ADDENDUM

Addendum: No. 2
Tender no: RFT-DRK-17-005-0
Date: June 6th, 2017
Re: Daycare Renovation at Kanata Public Elementary School

Addendum No. 1

Architectural Addendum No. 1

DRAWN:	J. PILON	DRAWING No.	ADD S1
DESIGNED:	G. FALCOMER		S101
APPROVED:	B. WEATHERDON		
DATE:	JUNE 02/17		
SCALE:	AS SHOWN		
PROJECT No:	17-2168

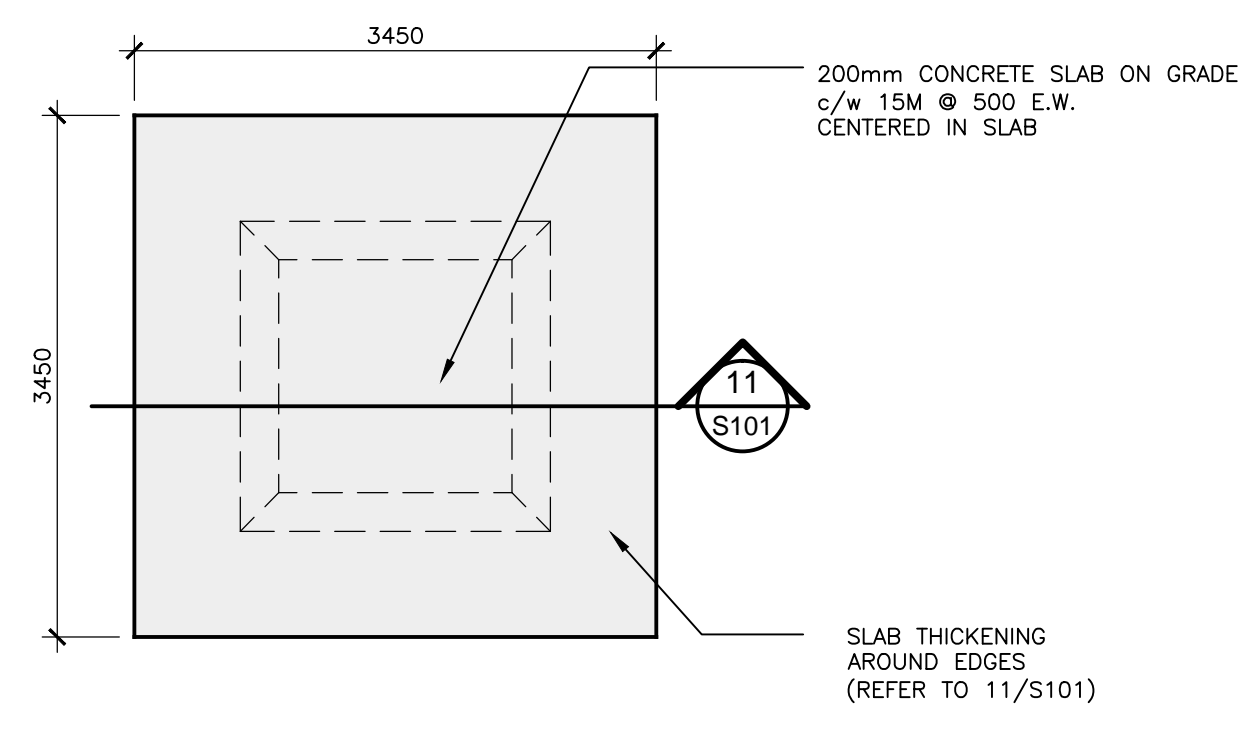
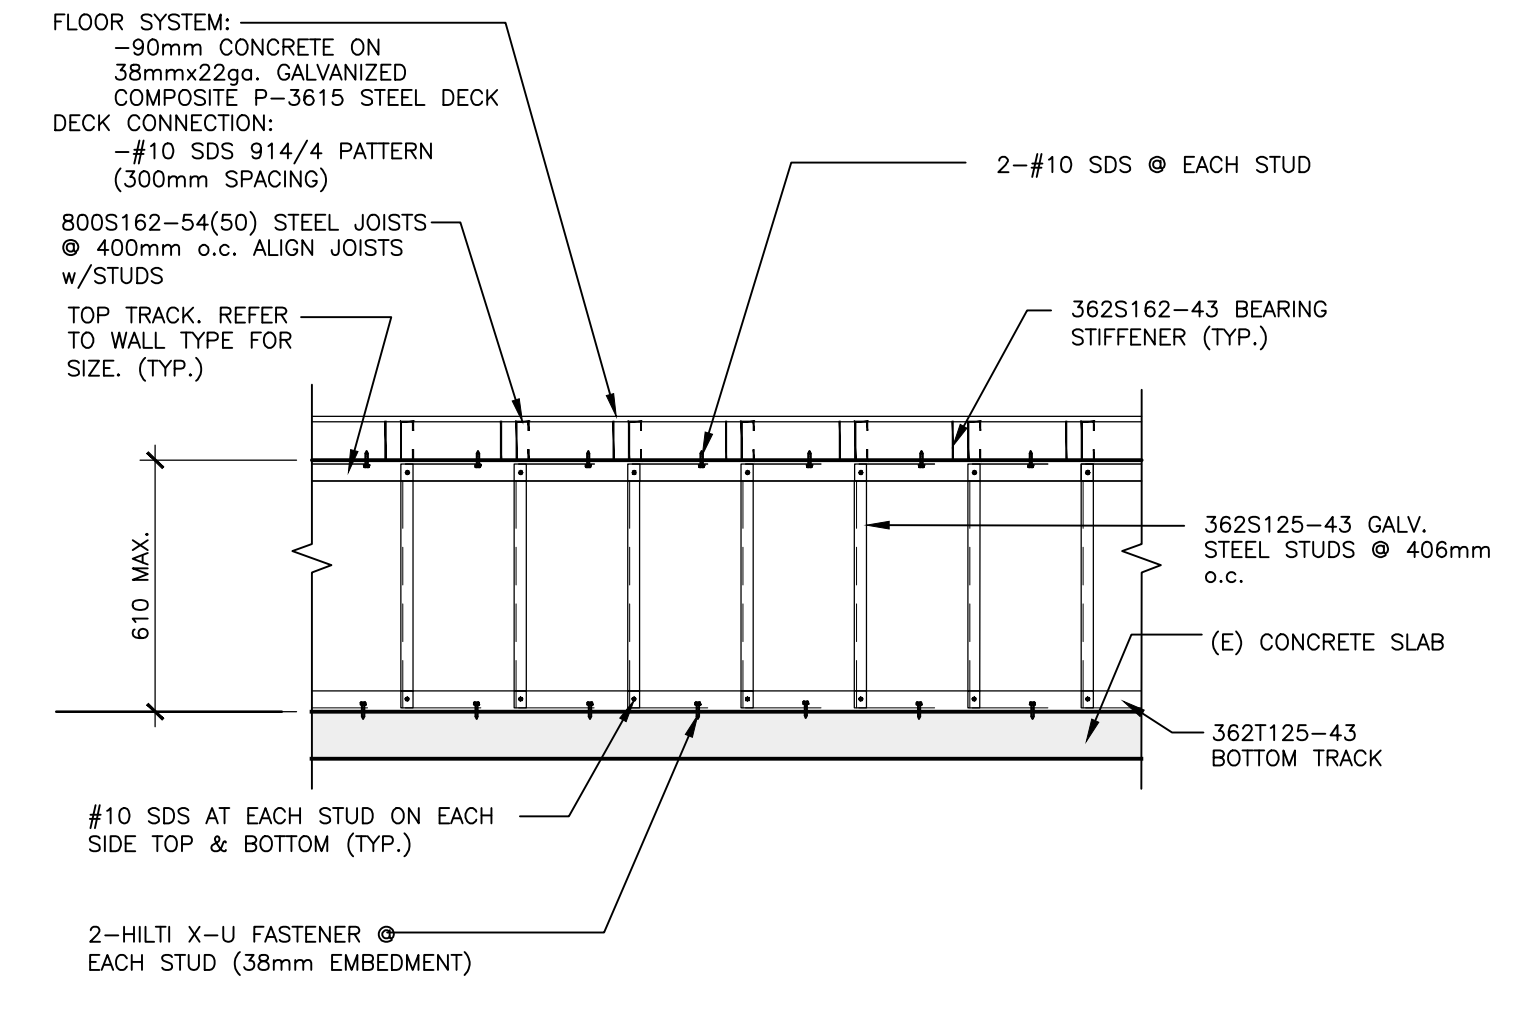
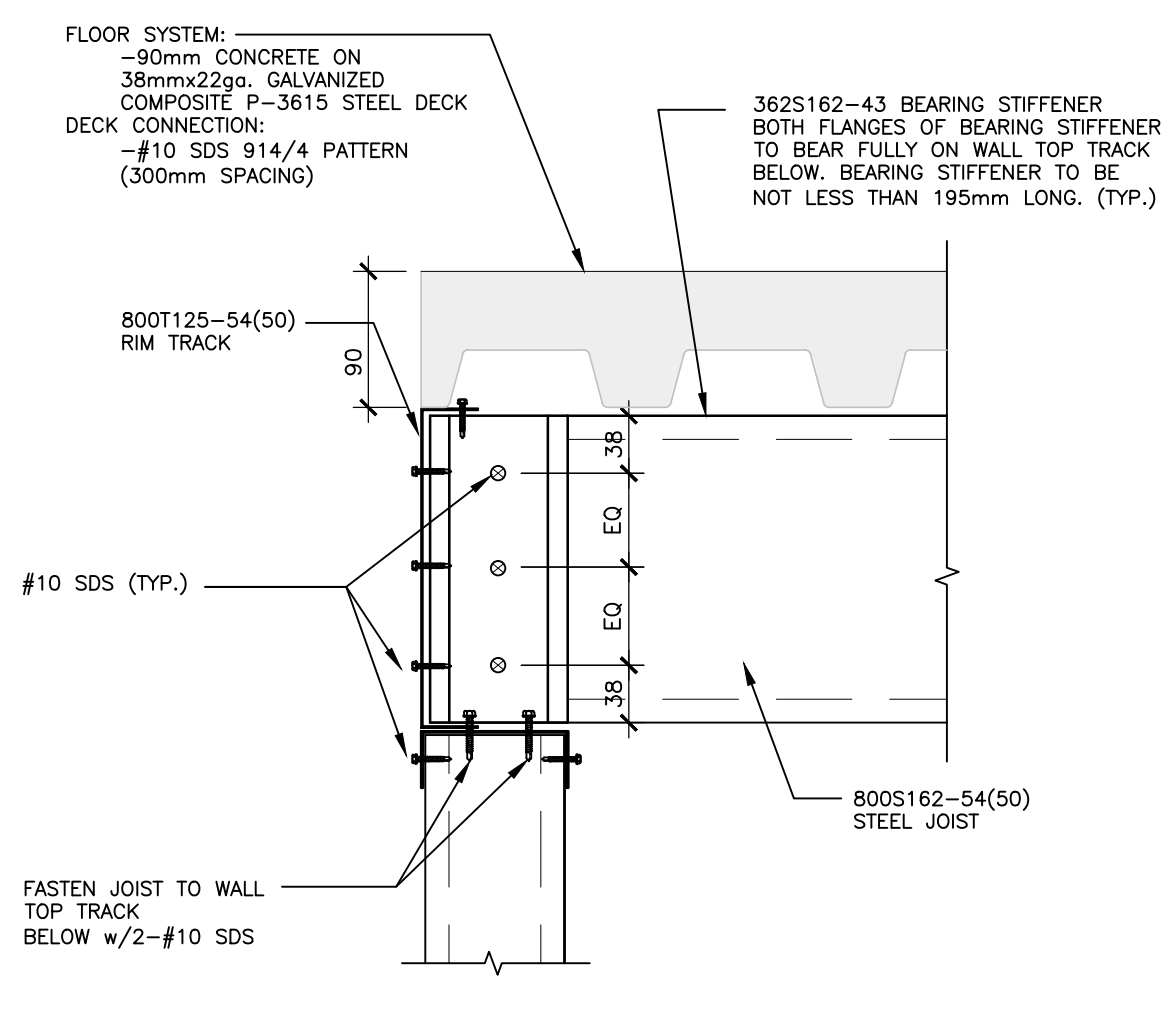
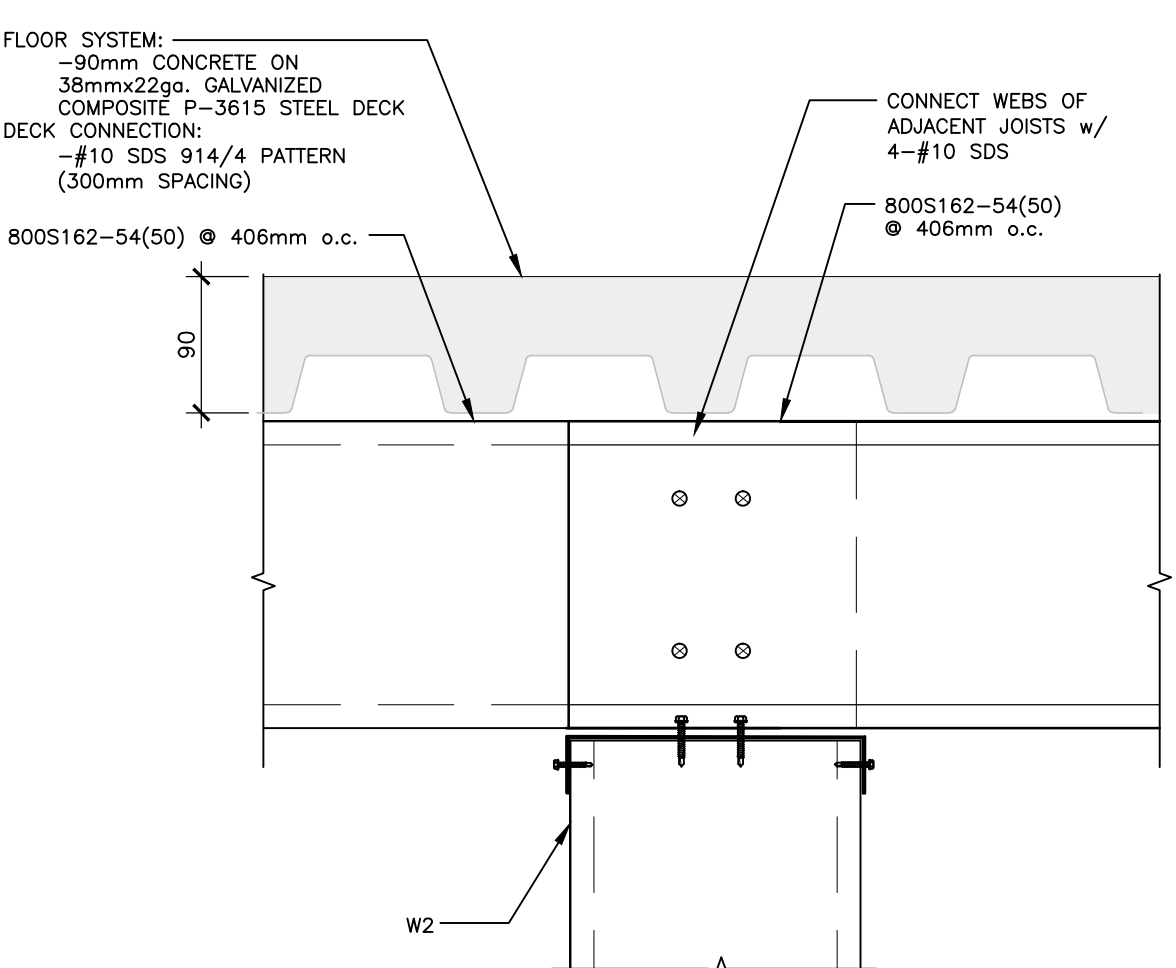
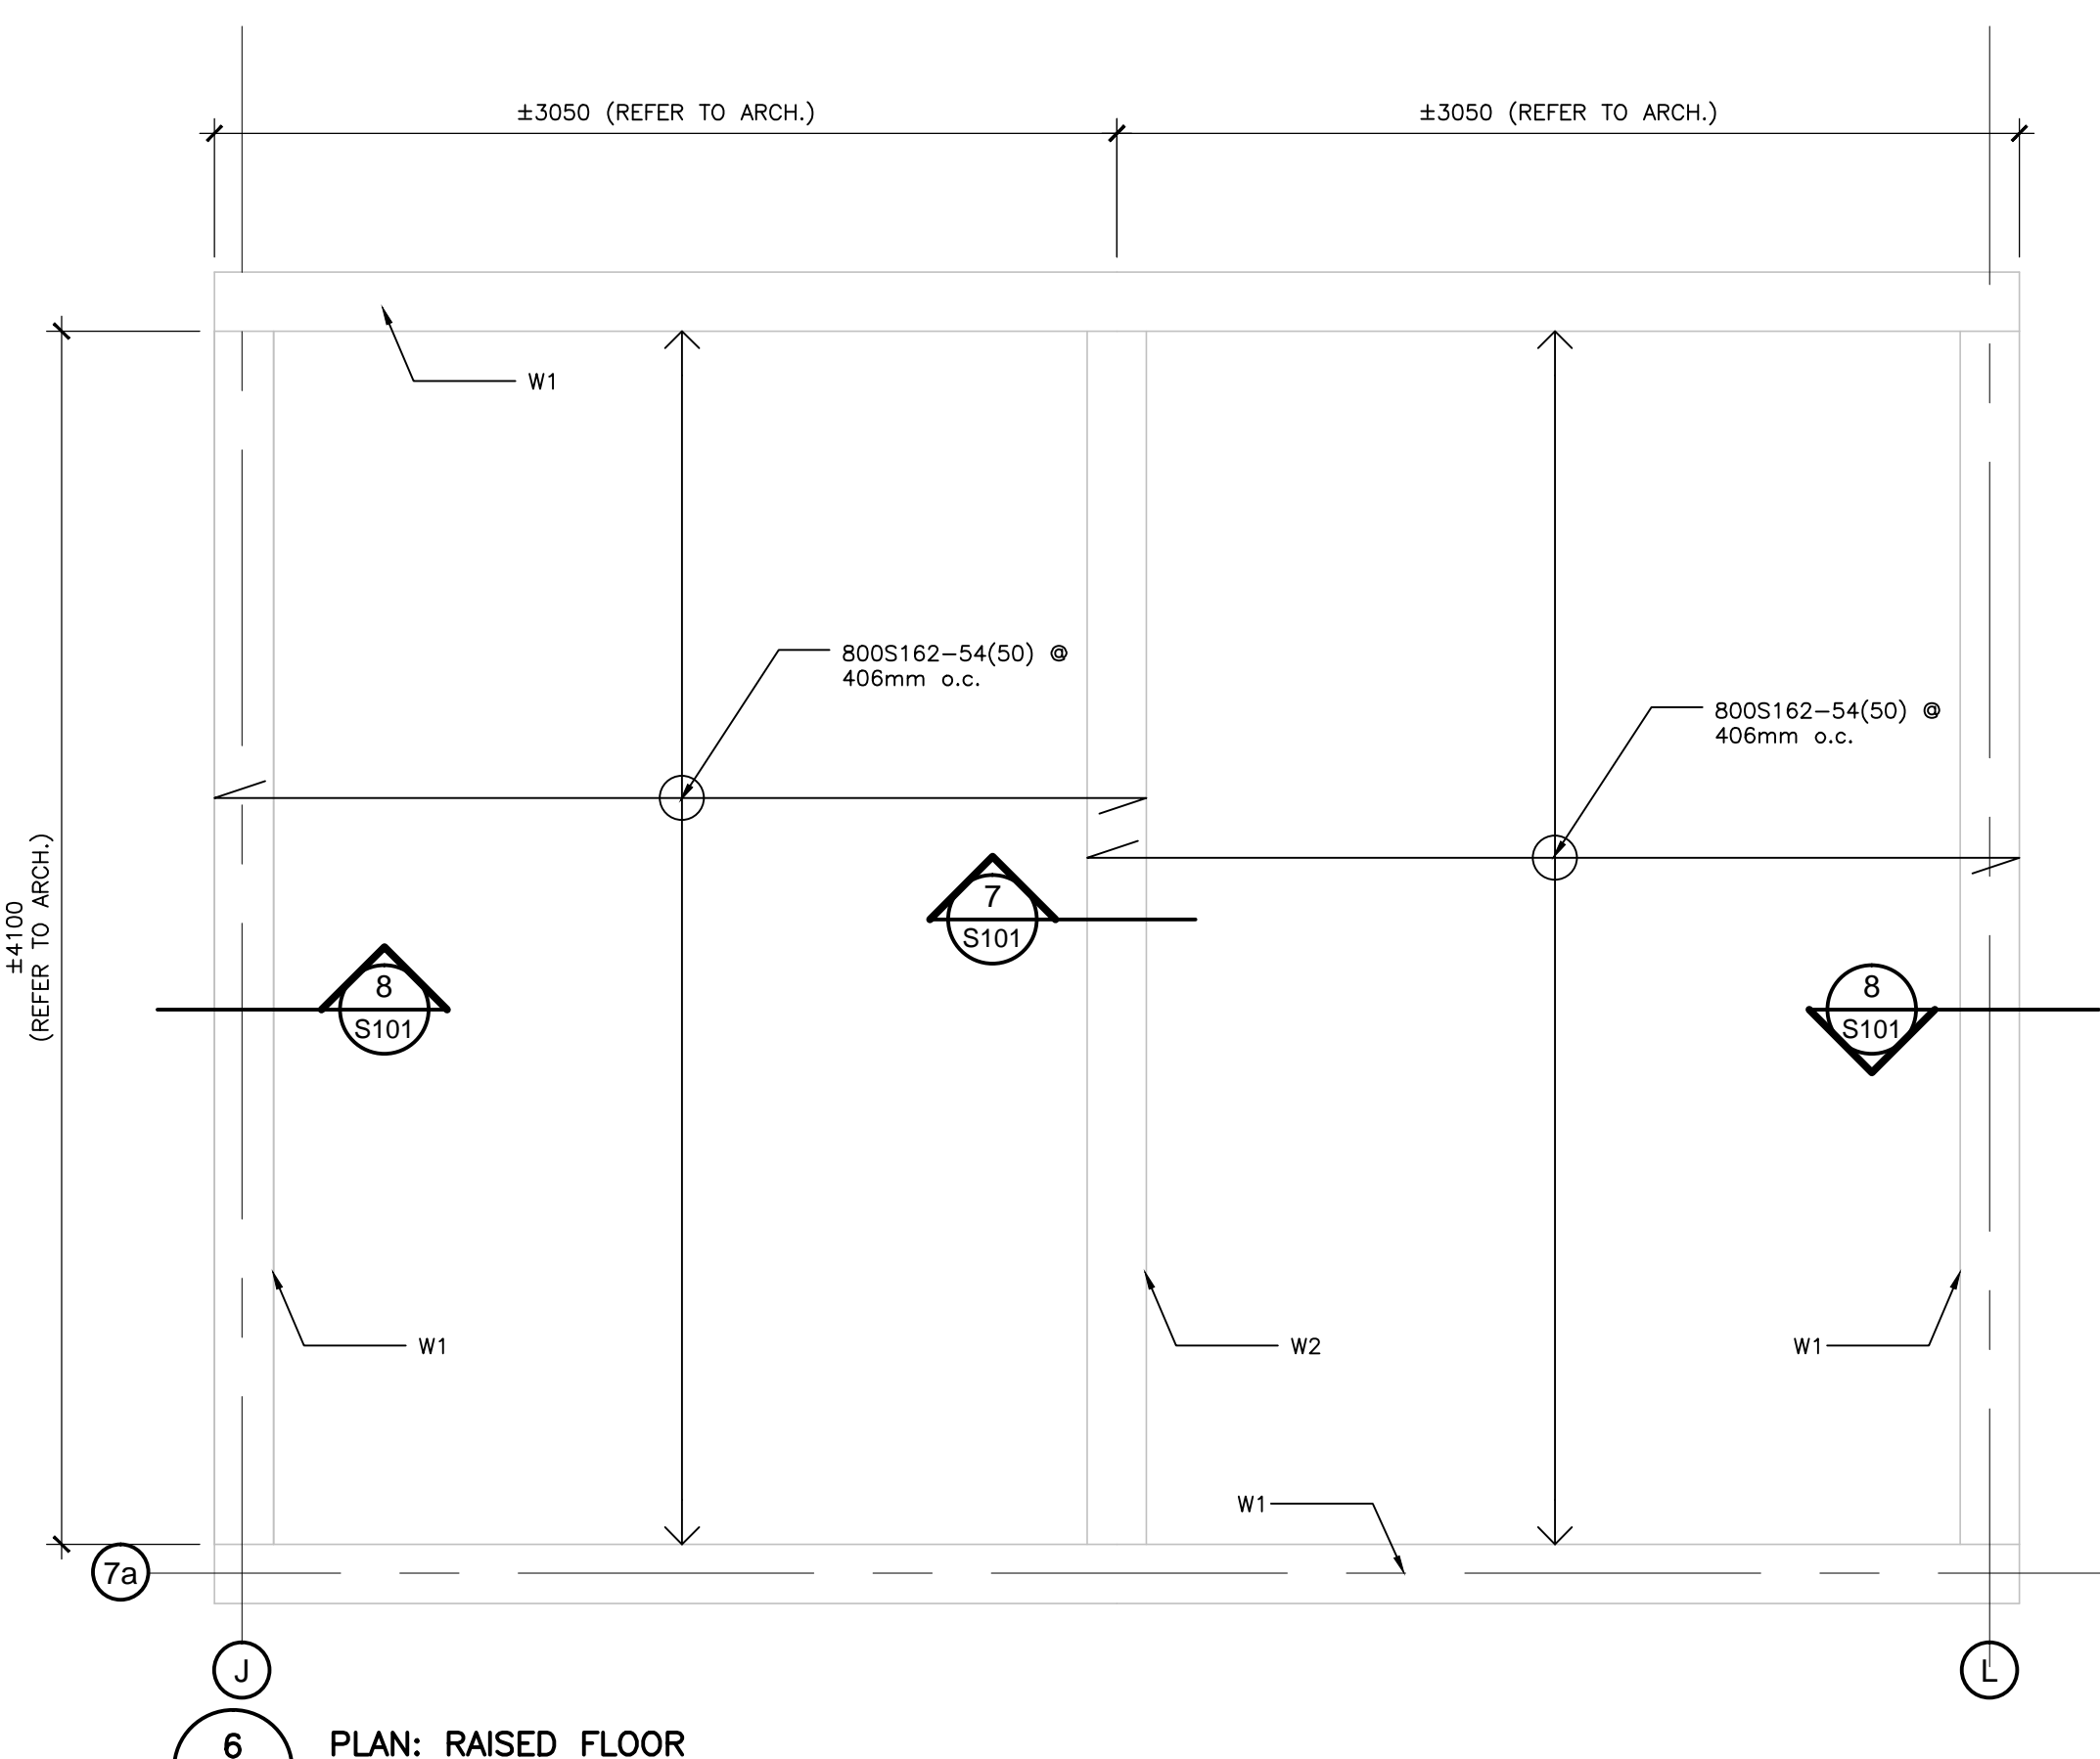
2. **ADD S1 S101:**
 - a. Provide new structural steel framing around edges of openings and edges of unit for new roof top unit and new roof top exhaust fan.
 - b. Provide seismic reinforcing for new roof top unit curb.
 - c. Provide new raised floor comprised of concrete on composite steel deck supported on cold-formed steel joists bearing on cold-formed steel stud walls.
 - d. Provide new concrete slab on grade.
